# UNITED STATES PATENT AND TRADEMARK OFFICE

APPLICATION NO.	FILING DATE	FIRST NAMED INVENTOR	ATTORNEY DOCKET NO.	CONFIRMATION NO.
10/768,949	01/30/2004	Noriko Nawata	AA613	8511

<b>Office Action Summary</b>	<b>Application No.</b> 10/768,949	<b>Applicant(s)</b> NAWATA ET AL.	
	<b>Examiner</b> Michael G. Bogart	<b>Art Unit</b> 3761

## **DETAILED ACTION**

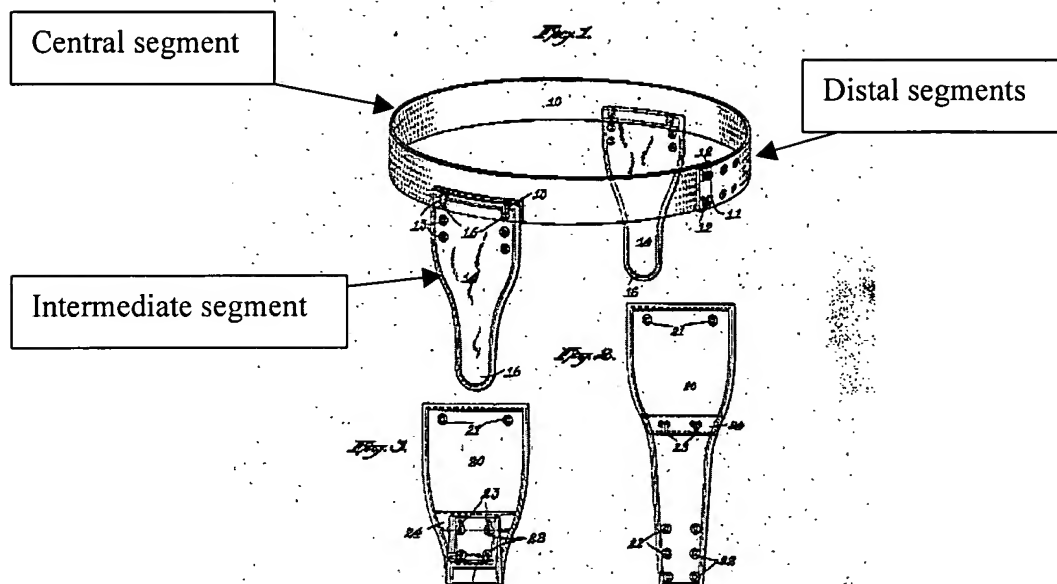
Regarding claim 1, Stein teaches a waist belt (10) for supporting a disposable absorbent assembly, the belt (10) having a longitudinal centerline, a transverse centerline, a wearer-facing surface, an opposing surface, two end edges oppositely disposed with respect to the transverse centerline, and two side edges oppositely disposed with respect to the longitudinal centerline;

the belt comprising a central segment, at least two intermediate segments (16) and at least two distal segments;

the central segment being positioned along the longitudinal centerline and extending transversely outwardly from the longitudinal centerline on either side of the longitudinal centerline, the central segment having a first longitudinal length defined by the distance between the end edges of the central segment;

each intermediate segment (16) transversely outwardly extending from the central segment and being positioned between the central segment and a distal segment, each intermediate segment positionable over a side hip of the wearer when the belt (10) is worn, each intermediate segment (16) having a second longitudinal length defined by the distance between the end edges of each intermediate segment (16);

each distal segment extending transversely outwardly from an intermediate segment (16) and including one of the side edges of the belt, each distal segment having a third longitudinal length defined by the distance between the end edges of each distal segment;

wherein the second longitudinal length is greater than the first longitudinal length, and greater than the third longitudinal length (as measured from the top surface of the belt when worn, to the bottom surface); and

wherein the belt (10) comprises a fastener element (11, 12) positioned on at least one of the distal segments for releasably securing the belt (10) around the waist of the wearer, and an attachment surface (22, 23, 24) formed at least on the opposing surface of each intermediate segment (16) for releasably attaching the disposable assembly to the belt (10)(see figures 1-3, below).

Regarding claim 2, Stein teaches that the distal segments have the same connectors (11, 12) as the intermediate segments (16) and can attach in the same manner to an absorbent article.
